Model: Kingfisher 2		Date: 15-Sep-99	No.: RA298001
Subject: Differences from Kingfisher		Prepared by: K. Miura	
From: Technical Service Dept., GTS Division			
Classification:	<input type="checkbox"/> Troubleshooting	<input type="checkbox"/> Part information	<input type="checkbox"/> Action required
	<input type="checkbox"/> Mechanical	<input type="checkbox"/> Electrical	<input checked="" type="checkbox"/> Service manual revision
	<input type="checkbox"/> Paper path	<input type="checkbox"/> Transmit/receive	<input type="checkbox"/> Retrofit information
	<input type="checkbox"/> Other ()

The new models, "Kingfisher 2 (A298)" and "Grand Kingfisher 2" will be launched in November '99. They are slightly modified versions of the already existing models "Kingfisher (Ricoh FT4015, Gestetner 2715z, Nashuatec 3715, Rex-Rotary 8715Z, Savin 9115, Infotec 5151 z)" and "Grand Kingfisher (Ricoh FT4618, Gestetner 2718z, Nashuatec 3718, Rex-Rotary 8718Z, Savin 9118, Infotec 5181 z)".

This RTB clarifies the differences between the base copier and Kingfisher 2 and Grand Kingfisher 2 (based on the style of the service manual).

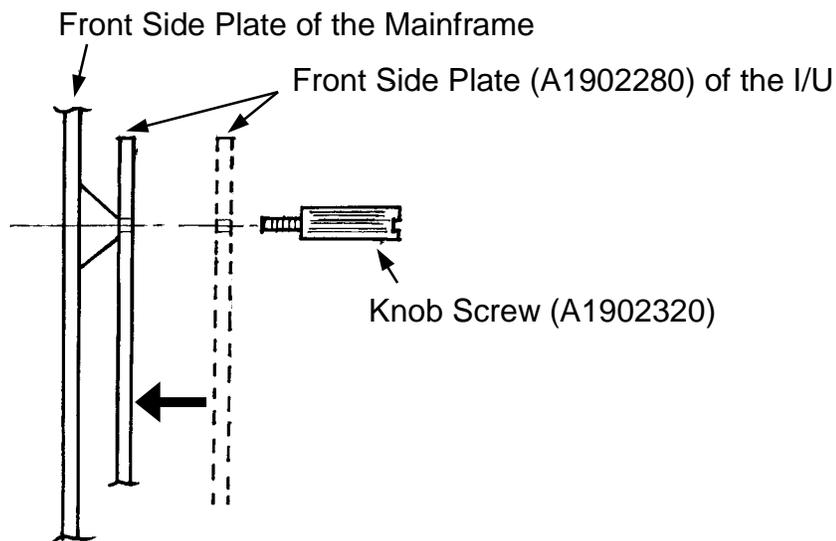
The TD sensor connector (A1905346: Development Unit Harness) which is mounted on the I/U (Imaging Unit) is not properly connected to the connector of the Development Relay Board (A1905145). The board is mounted on the rear side plate of the mainframe.

If the service technician does not tighten the knob screw *while* pushing the I/U against the raised portion of the mainframe front side plate, the TD sensor connector will not be fully inserted into the receiving connector on the board.

- 1) Insert the I/U into the mainframe.
- 2) Push the I/U toward the back so that the I/U front side plate(A1902280) remains flush against the raised portion of the front side plate of the mainframe (see the illustration below). While holding the unit in this position (pushing on the handle), tighten the knob screw (A1902320) by hand until the I/U is secure.

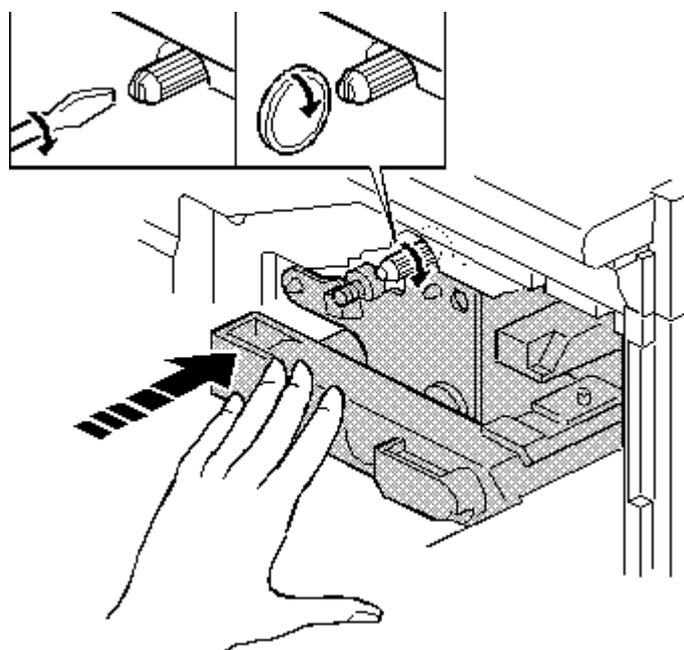
The procedure for installing the imaging unit in the copier has been replaced with a more detailed description. Please make sure to install the unit in this way after pouring in the new developer at machine installation or developer replacement.

8. Remount the cover on the imaging unit, and install the unit in the copier (1 knob screw).
Then turn the "B1" lever clockwise to raise the transfer corona unit.

8. Remount the cover on the imaging unit and insert the unit into the mainframe. Push the unit toward the back until it stops. While holding the unit in this position, tighten the knob screw by hand. For the final tightening, use a screwdriver or coin as shown in the illustration. Then turn the B1 lever clockwise to raise the transfer corona unit.

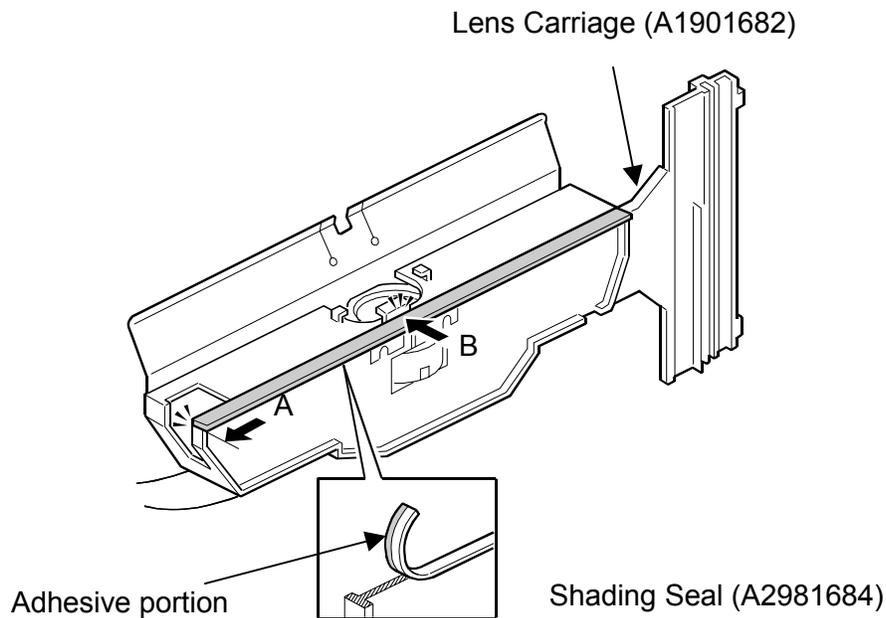
When the 1st and 2nd scanners start to move, part of the light from the 1st scanner is directly sent to the mirror of the 2nd scanner, as the two scanners are relatively close. This "extra light" received by the mirror will cause the image to appear lighter. As scanning continues, the 1st scanner increases to twice the speed of the 2nd scanner, causing the two scanners to get farther and farther apart. Therefore, less and less light "extra light" reaches the 2nd scanner mirror. This is why the image is lighter near the leading edge.

A shading seal (A2981684) should be attached to ensure proper image density at the leading edge (when making copies with very light/halftone originals). Because the extra light passes from the 2nd scanner mirror to the photoconductor via the base plate of the optics unit and lens carriage (A1901682), the seal should be attached to the lower portion of the lens carriage. This will prevent the extra light from passing between the optic base plate and lens carriage. This modification will be applied from August 2000 production. Please see the procedure as shown below.

A: 0-1mm from the edge, B: 0-0.5mm from the surface

3. Attach the shading seal to the lens carriage as shown in the illustration.

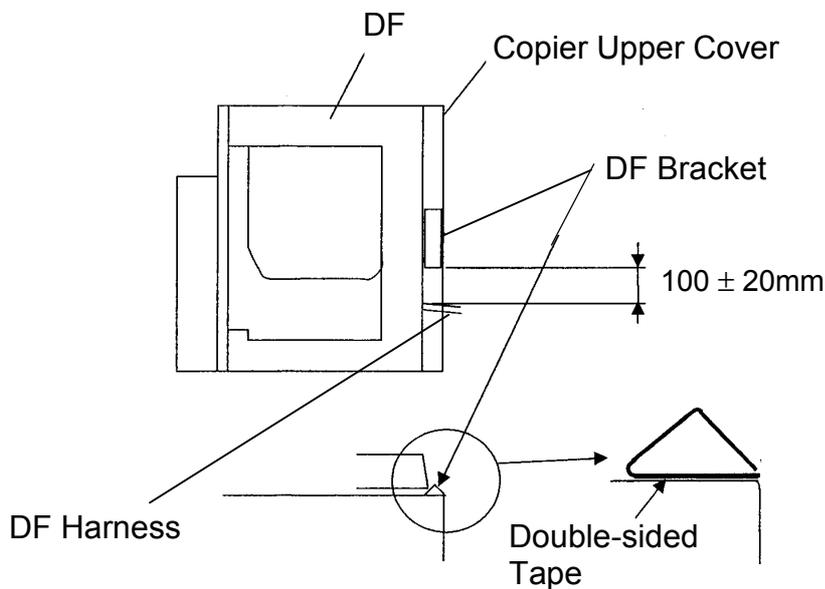
Sometimes, the DF is forced past its normal stop position when it is opened. If this happens many times, the harness may be damaged.

A DF bracket (PN A2989500) has been registered as a service part. Place it on the copier upper cover as shown below to prevent the DF unit from being forced too far back.
